ENGINE - NO.4 BEARING COMPARTMENT - REPLACE EXISTING TUBE ADAPTERS WITH TUBE ADAPTERS
HAVING A DECREASED INNER DIAMETER - CATEGORY CODE 5 - MOD.ENG-72-0148

V2500-ENG-72-0148

SERVICE BULLETIN

Location of the Adapter (Right Side View V2500-A5 and V2500-D5)
Fig.1 (Sheet 1)

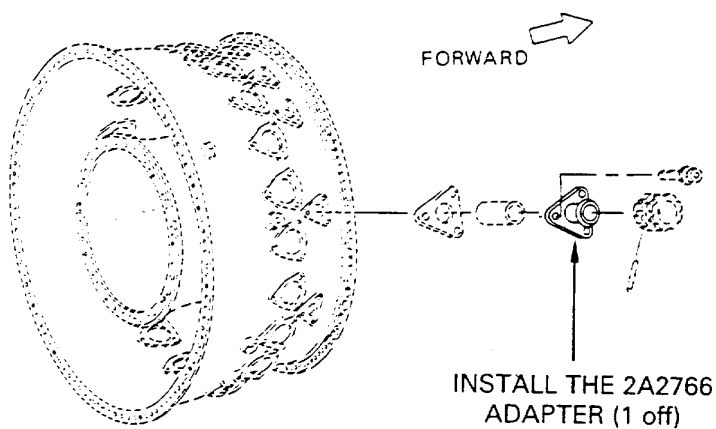
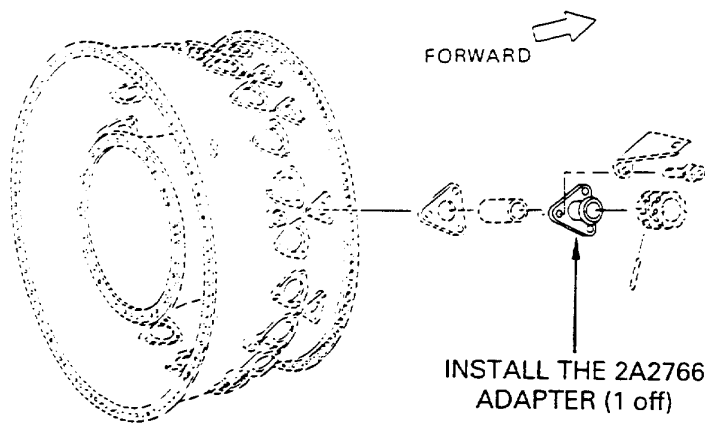
- (a) Remove the 2A1912 Adapters by the approved procedure given in Reference (2), Chapter/Section 72-42-00, Disassembly.

- (b) Install the 2A2776 Adapters (2 off) by the approved procedure given in Reference (2), Chapter/Section 72-42-00, Assembly, and Figure 1.

- (a) Remove the 2A1912 Adapter by the approved procedure given in Reference (3), Chapter/Section 72-42-00, Disassembly.

- (b) Install the 2A2776 Adapters (2 off) by the approved procedure given in Reference (3), Chapter/Section 72-42-00, Assembly, and Figure 1.
